Contract Change Order # 1

Project Name: Leisure Park I Mill&Overlay Project Number: ST1509A
Project Location: Leisure Park I Subdivision on Elm Pl. Date of Application: Wednesday, January 25, 2017
Contractor: H&G Paving Contractors, Inc. Submitted By: Brian Wimmer

RE: Request for Change – Hickory Ave.

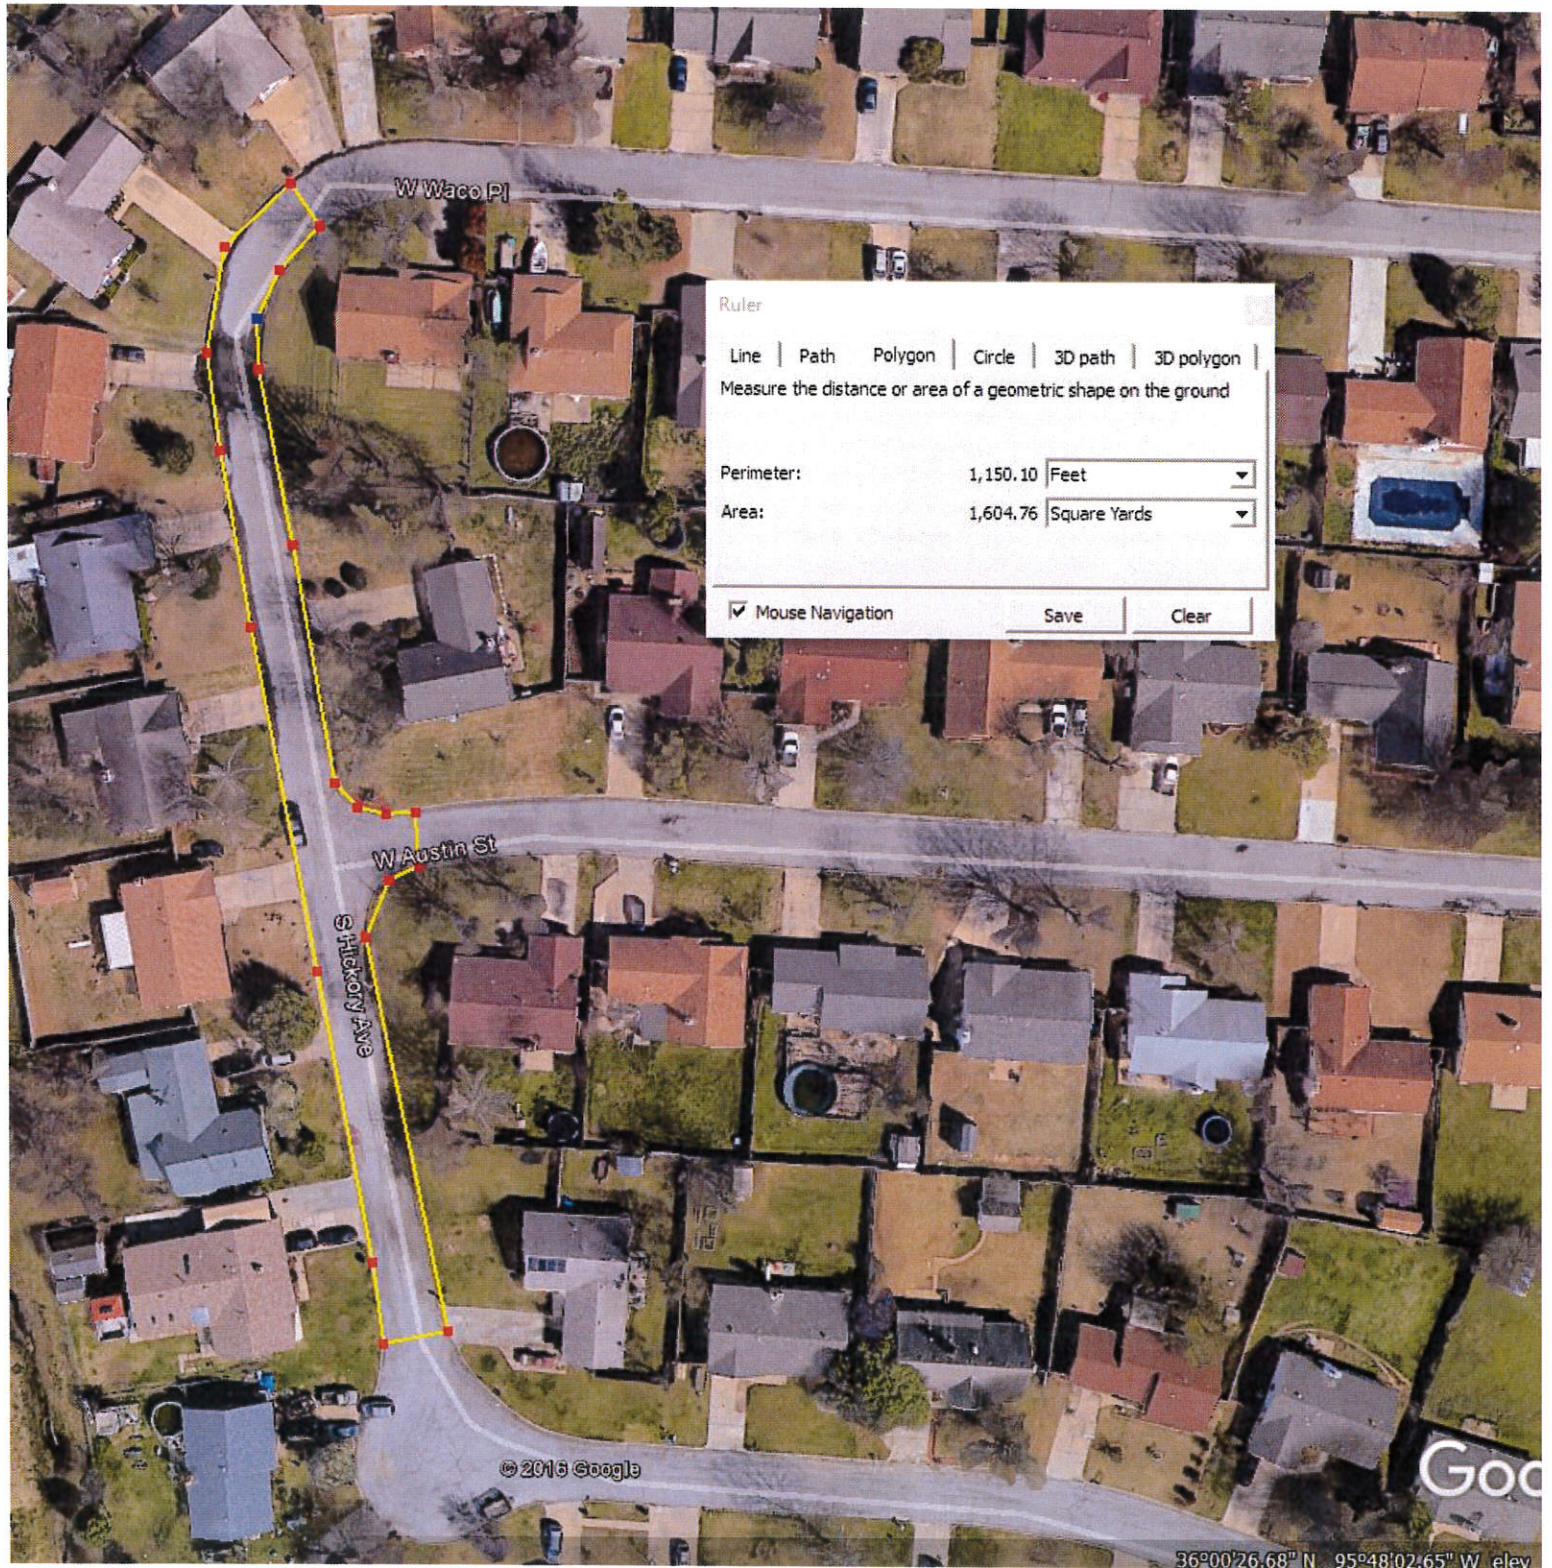
Due to soft and saturated subgrades consisting of fat clays, the contractor is directed to overexcavate (beyond original patch area) and additional 4 inches of subgrade, install Tencate Mirafi BXG 110 geogrid, and place an additional 4 inches of aggregate base in

- 1) combination with the 8 inches of aggregate base from the patch line item. This price consists quantity for 1605 sy as shown in the attached plan limits. Contract Administrator to set out final extents of 1605 SY in the field. Price is inclusive of all costs for above work.

Area: 1,604.76 Square Yards
